March 31, 1982
AW-82-21

APPLICATION FOR WITHHOLDING PROPRIETARY
INFORMATION FROM PUBLIC DISCLOSURE

SUBJECT: Response to Questions on WCAP-9561, "Bart-A1: A Computer Code for the Best Estimate Analysis of Reflood Transients" (Proprietary)

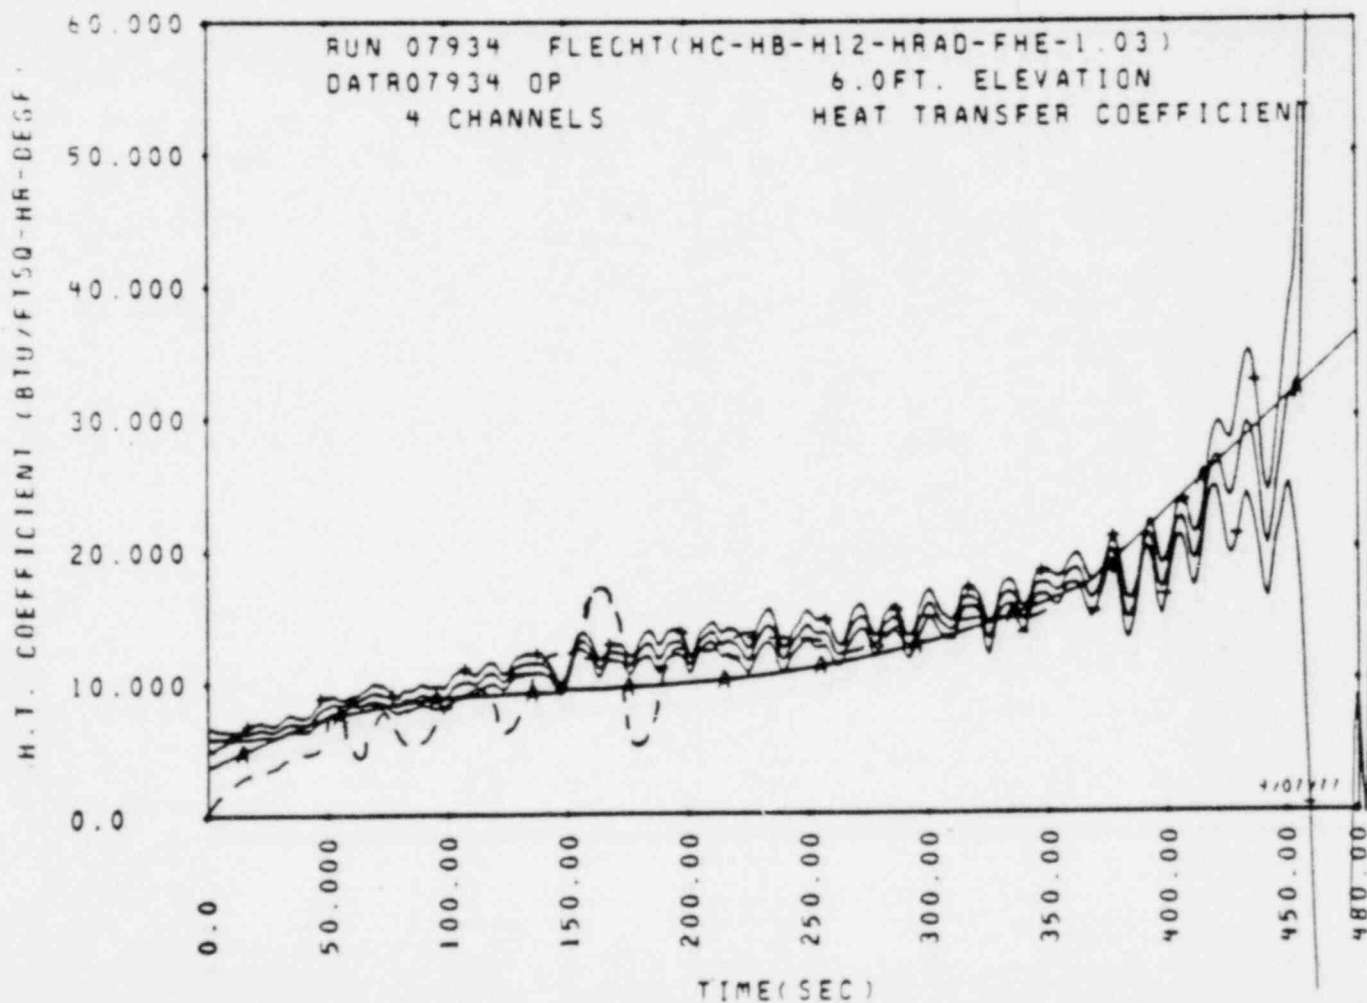
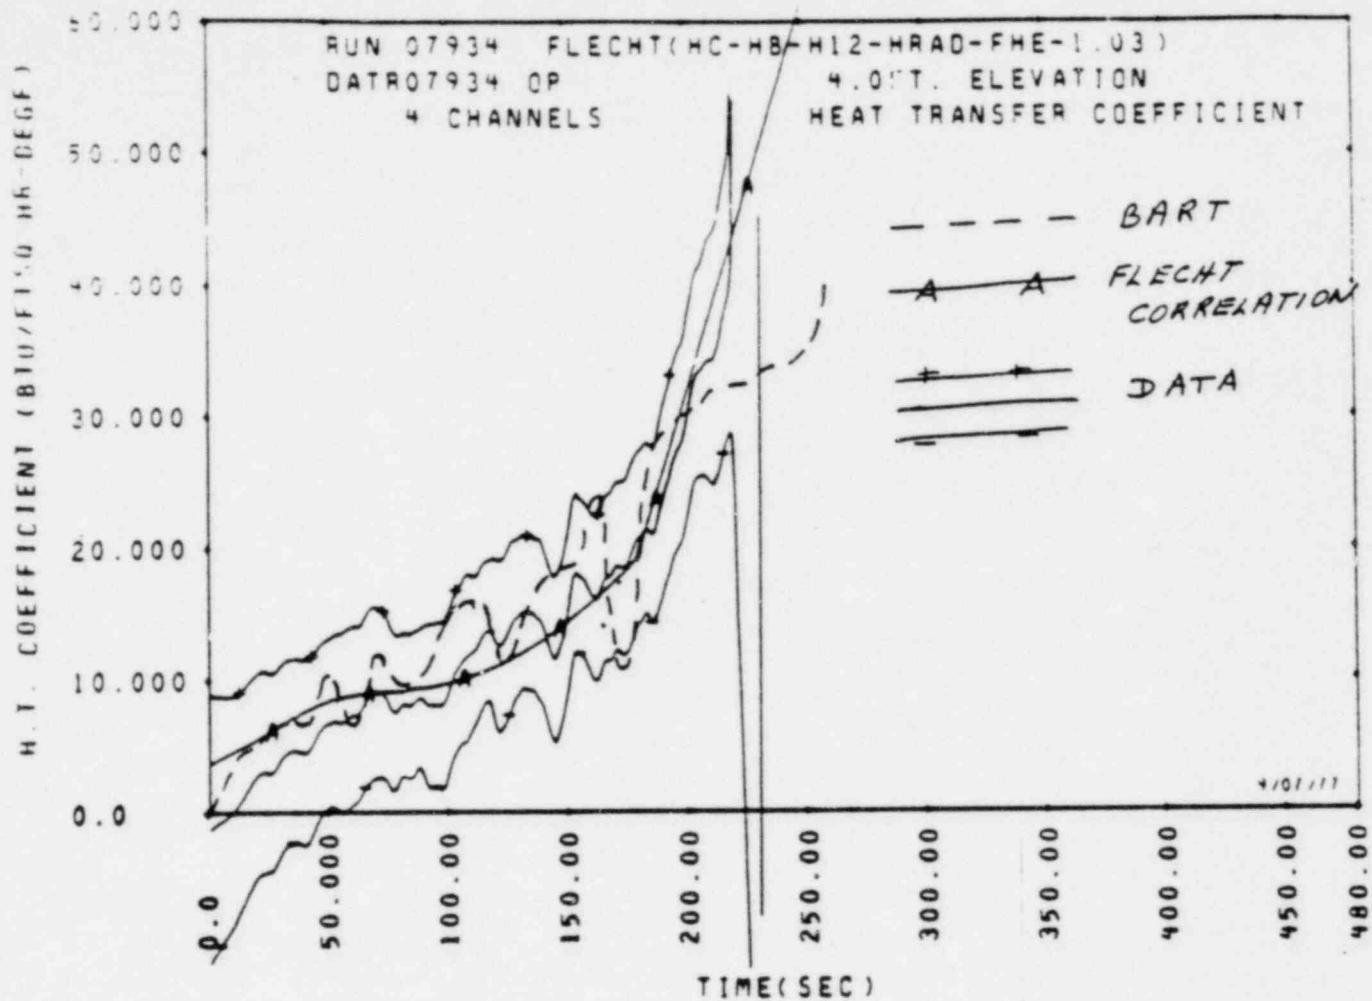
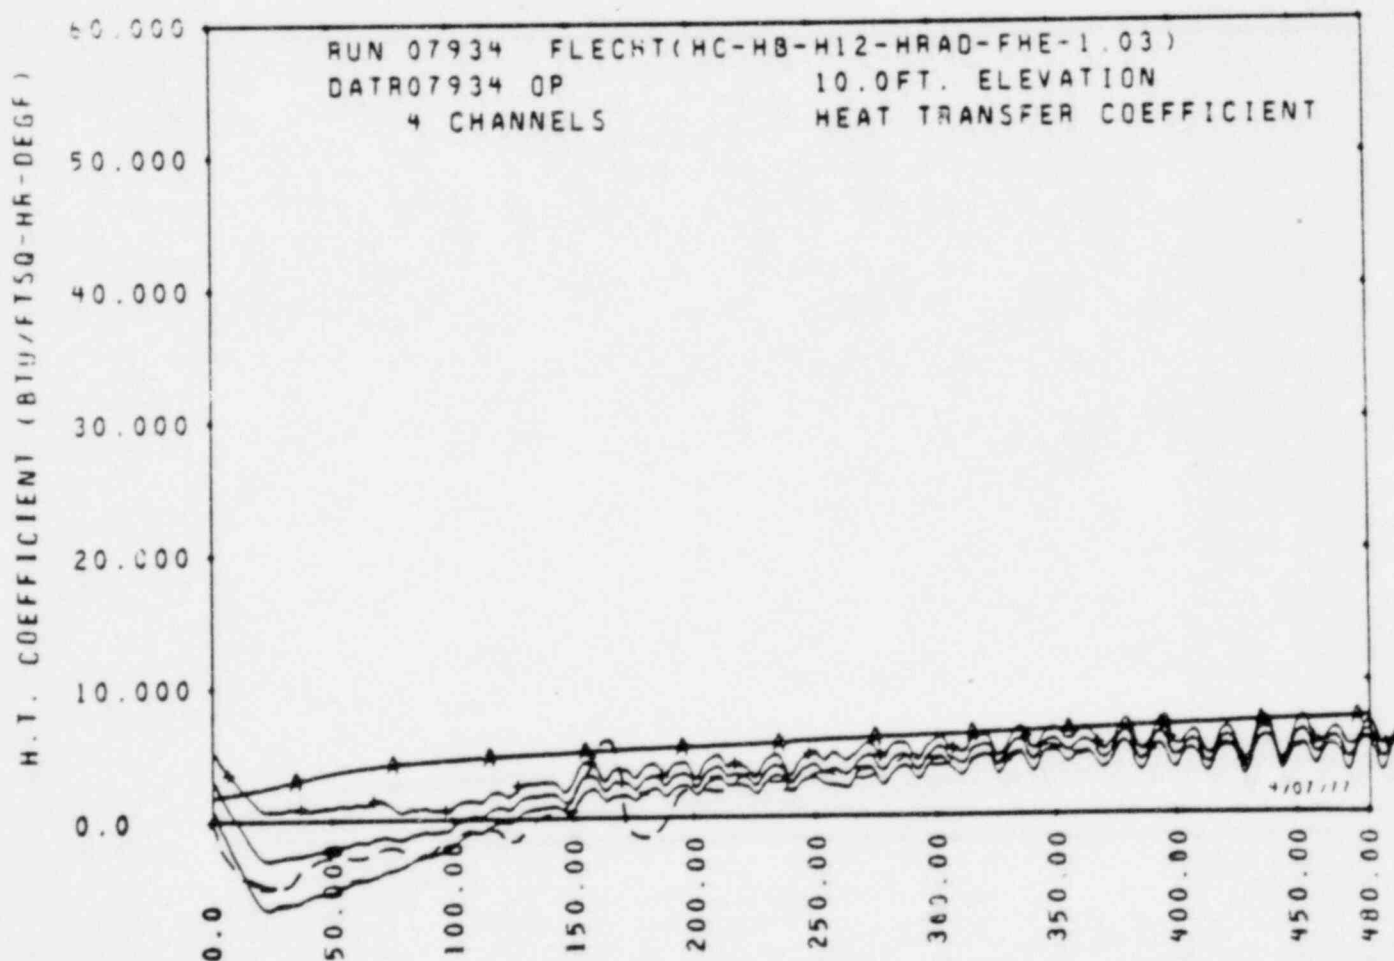
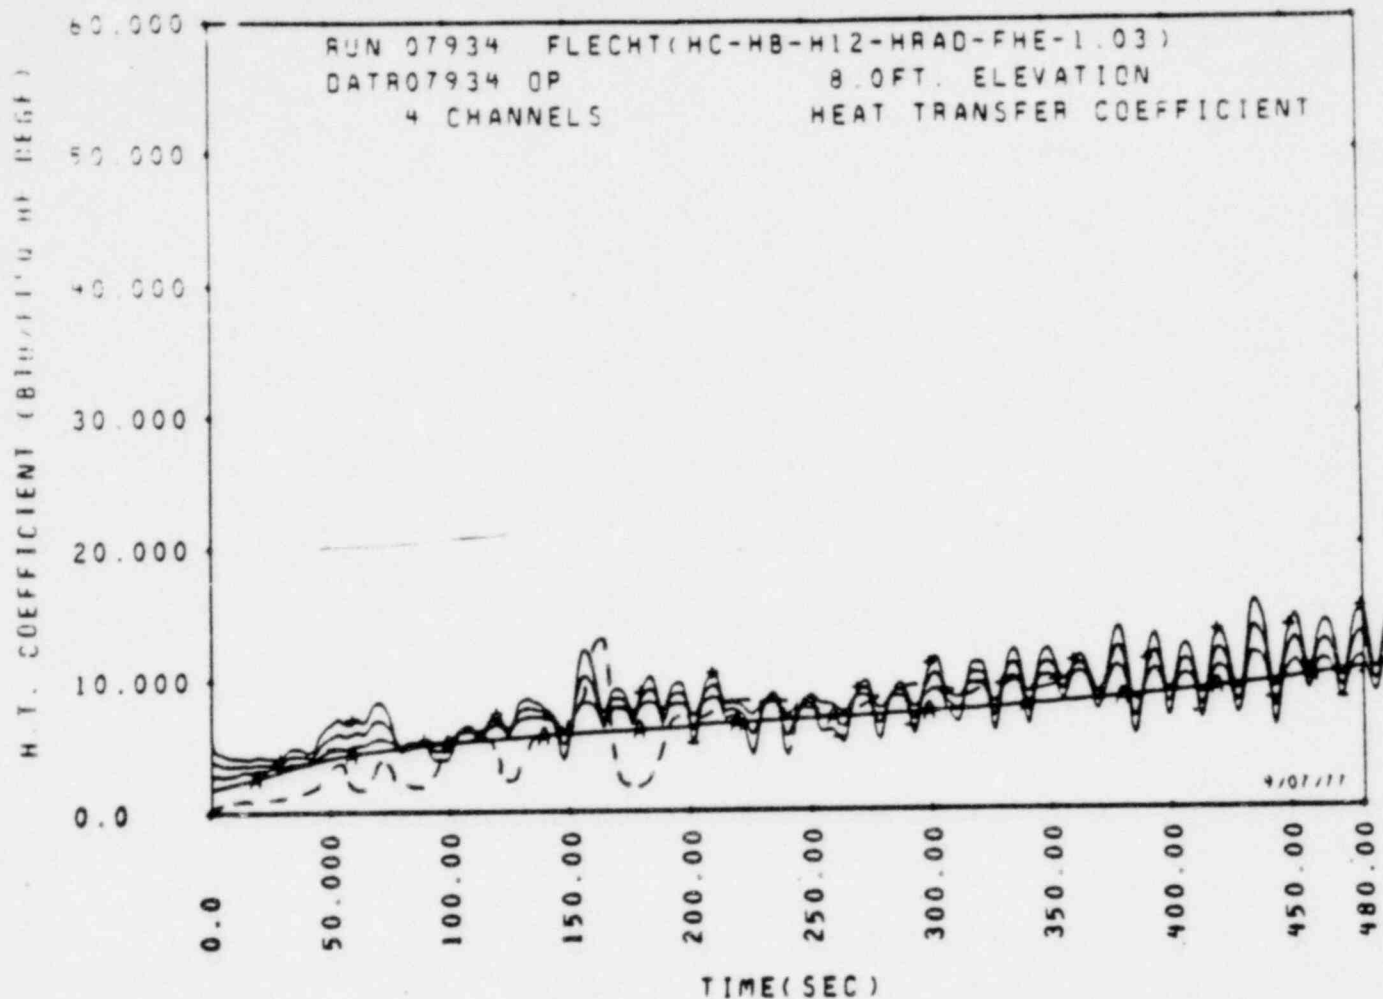
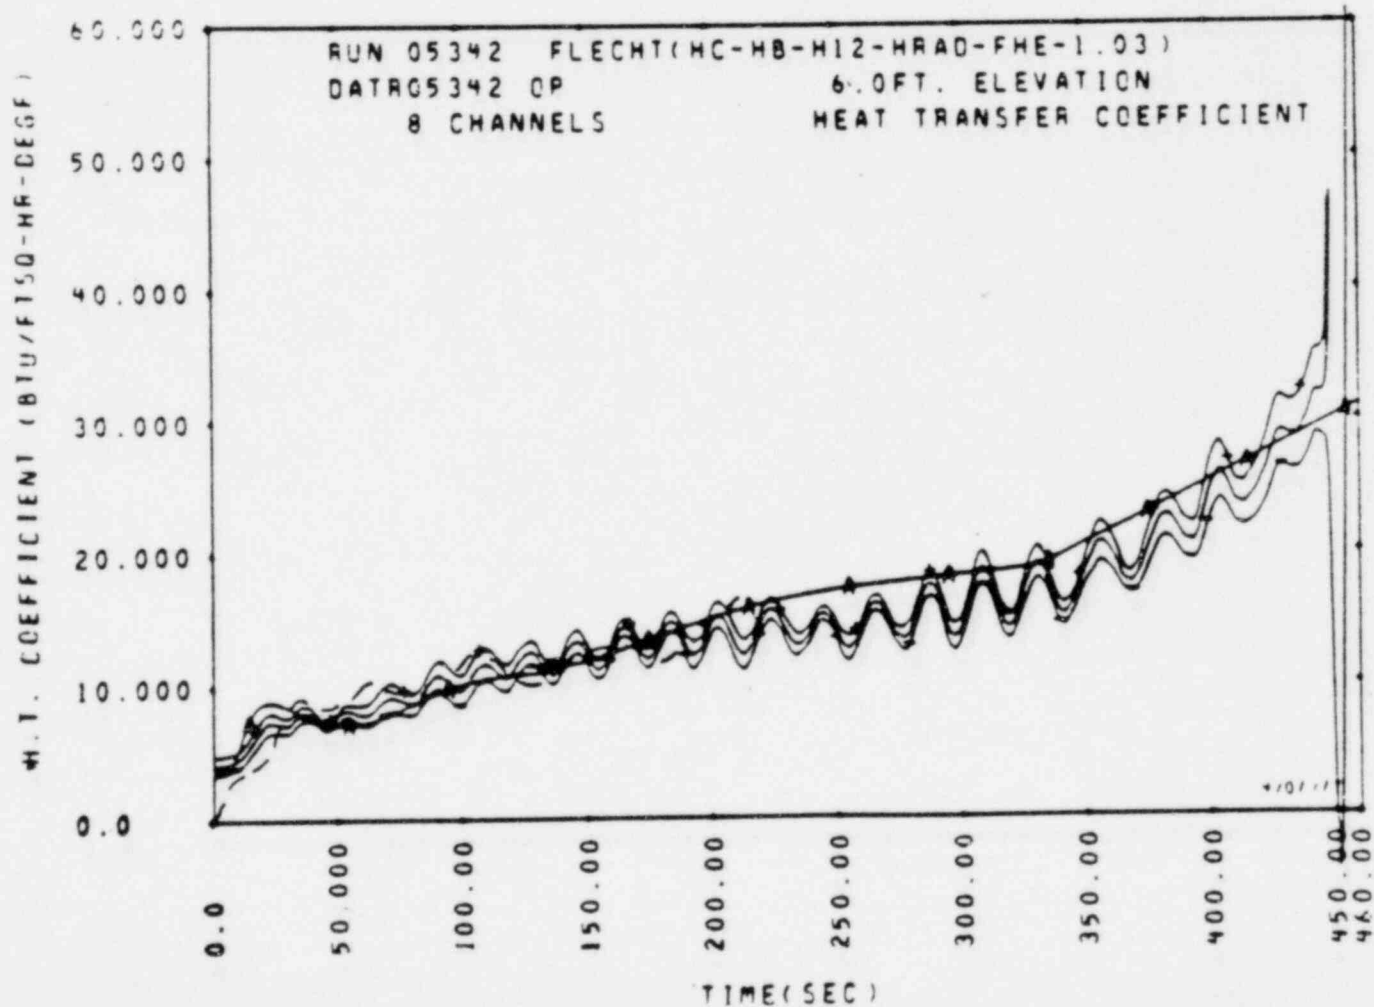
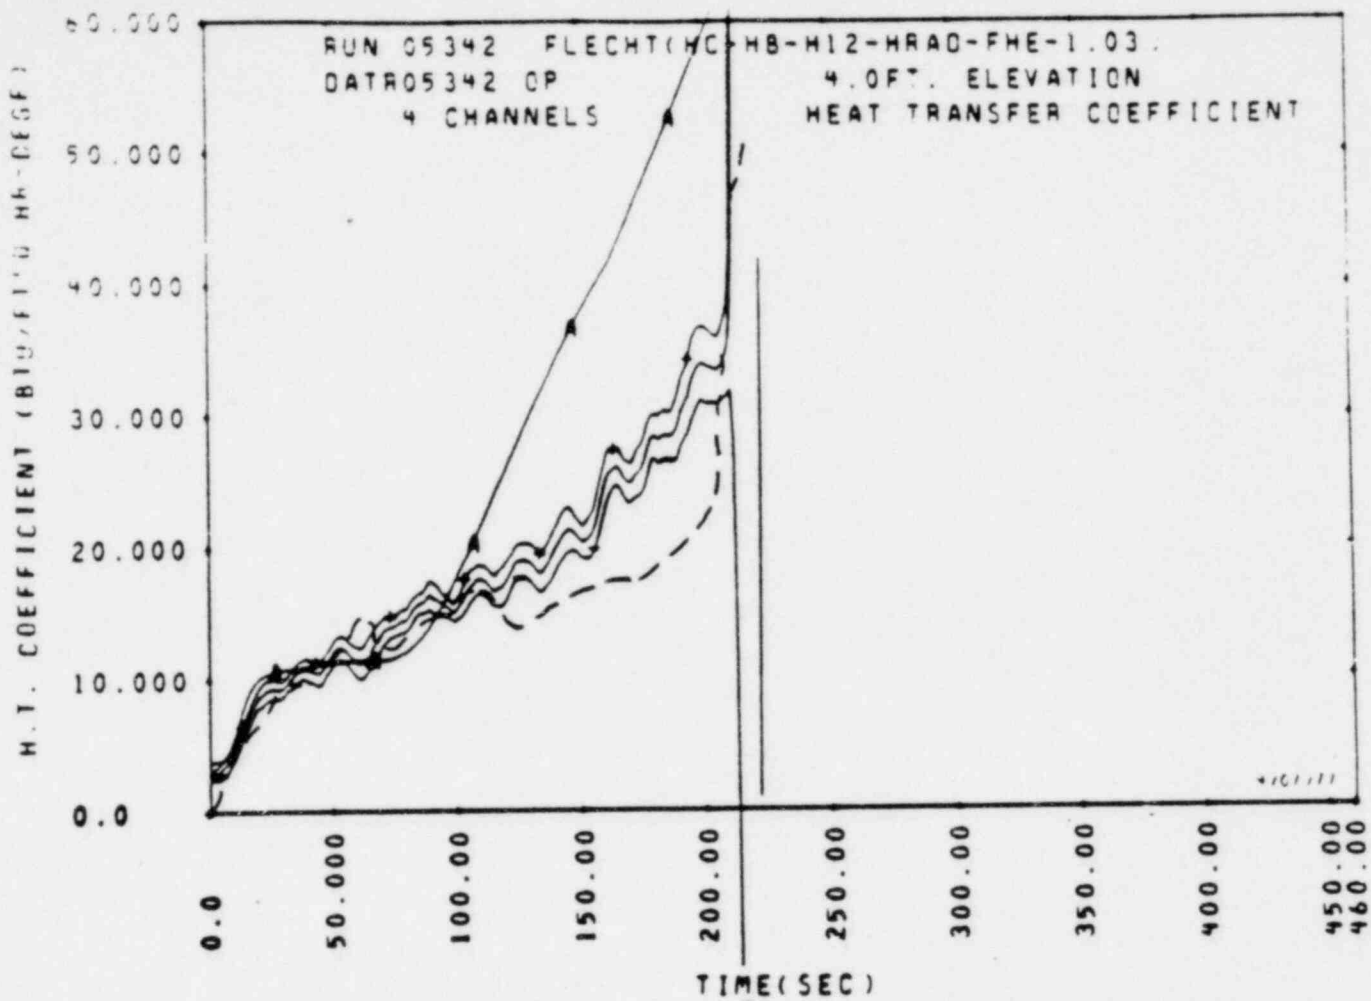
- 3.) A comparison of the surface heat transfer coefficient from both BART and the current FLECHT correlation should be provided.

The attached figures compare the BART calculated heat transfer coefficient (---) the FLECHT correlation (~~AAA~~) and data (—) for selected FLECHT cosine tests. It can be seen that BART agrees quite well with the data at all elevations (refer to WCAP 9561 for the test conditions).
